**AGENDA**  
**Cascade Charter Township Planning Commission**  
**Monday, April 19, 2021**  
**7:00 pm**  
**Virtual Meeting**

STAFF REPORT: Case #21-3629/Bob Morse  
REPORT DATE: April 15, 2021  
PREPARED FOR: Cascade Charter Township Planning Commission  
MEETING DATE: April 19, 2021  
PREPARED BY: Brian Hilbrands, Planner

REQUESTED ACTION: Basic Plan Review for an amendment to the PUD to accommodate  
a new car wash.

| SHEET NUMBER   | C-101       |

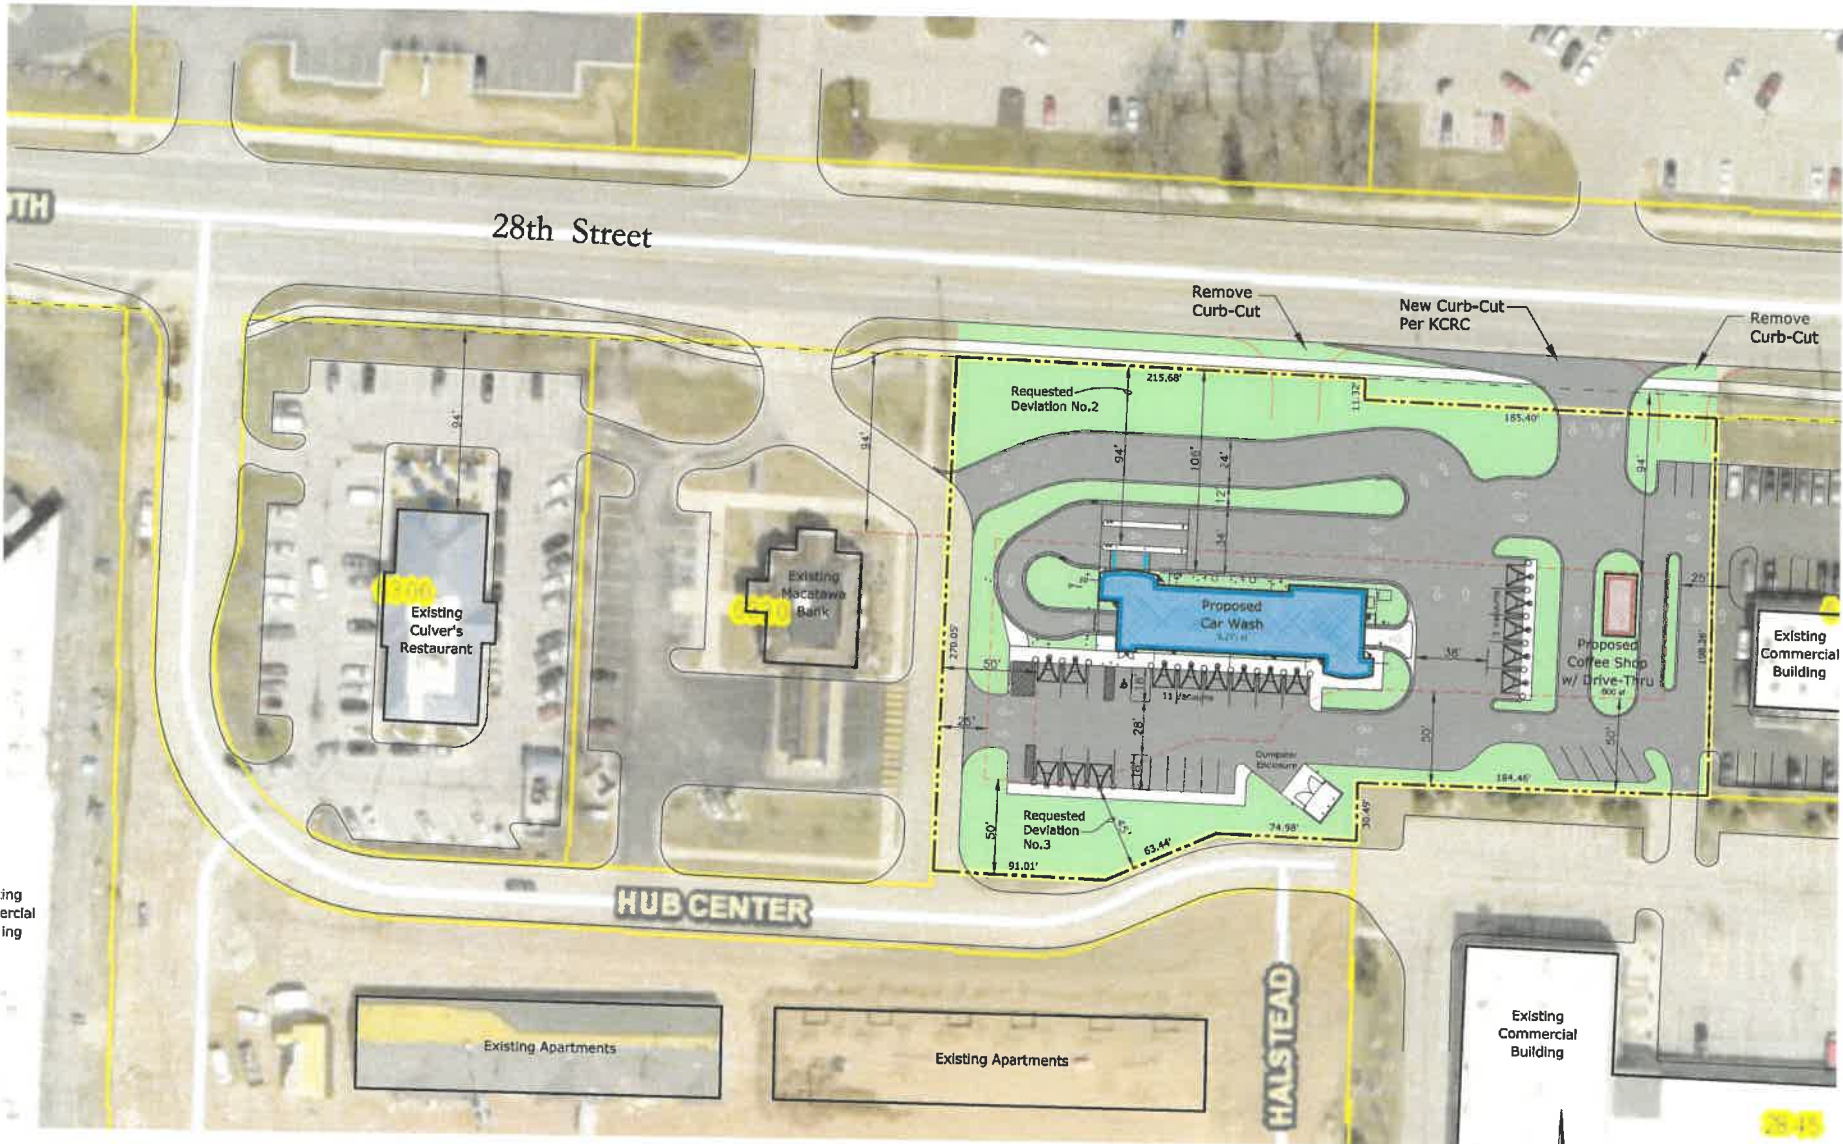
7. The proposed plan allows for cross-access to all the neighboring parcels. The plan shows a one-way drive accessing the commercial parcel to the southeast. Staff would recommend that this be a two-way drive for better access.

8. The proposed combined parcel currently has two curb cuts along 28<sup>th</sup> Street, one from the original Pizza Hut parcel and one from the motel parcel. The applicant is proposing eliminating one curb cut and shifting the other to align with a curb cut across the street. This would be subject to approval from the road commission. The PUD Ordinance as currently written states that the Pizza Hut parcel is not permitted to have access directly to 28<sup>th</sup> Street. However, with the curb cut from the motel parcel being added it seems to be a good tradeoff to allow this curb cut to remain if it is being realigned with one across the street.

10. A landscaping plan is required. This should include bufferyard setback distances. Currently there is no bufferyard being shown along the east property line. Staff would prefer to see at least a small bufferyard, similar to what is between Culver's and Macatawa Bank.

11. The proposed plan shows a setback of 94' for the car wash building to 28<sup>th</sup> Street. This is below the 100' setback required in the B2 zoning district, but is consistent with the other buildings along 28<sup>th</sup> Street in the PUD.

12. There have not been any stormwater or utility plans submitted. A full civil plan set will be required so that the township engineer can review it. The stormwater system will need to be finalized before proceeding to the preliminary development plan review.

1. Approval from the KCRC and the Township Board for vacating the right-of-way.
2. The different parcels should be combined into one parcel
3. A full civil plan set
4. Removal of the coffee shop building from the site plan
5. Access drive in the southeast corner be revised to be two-way
6. Provisions in the general notes of the site plan for screening of the dumpster
7. Landscape plan that includes bufferyard setbacks. Include bufferyard along east property line
8. The location and type of any signs being proposed
9. Photometric plan
10. KCRC review and approval of the curb cut on 28<sup>th</sup> Street
11. Approval from the township engineer of all proposed stormwater drainage facilities or improvements
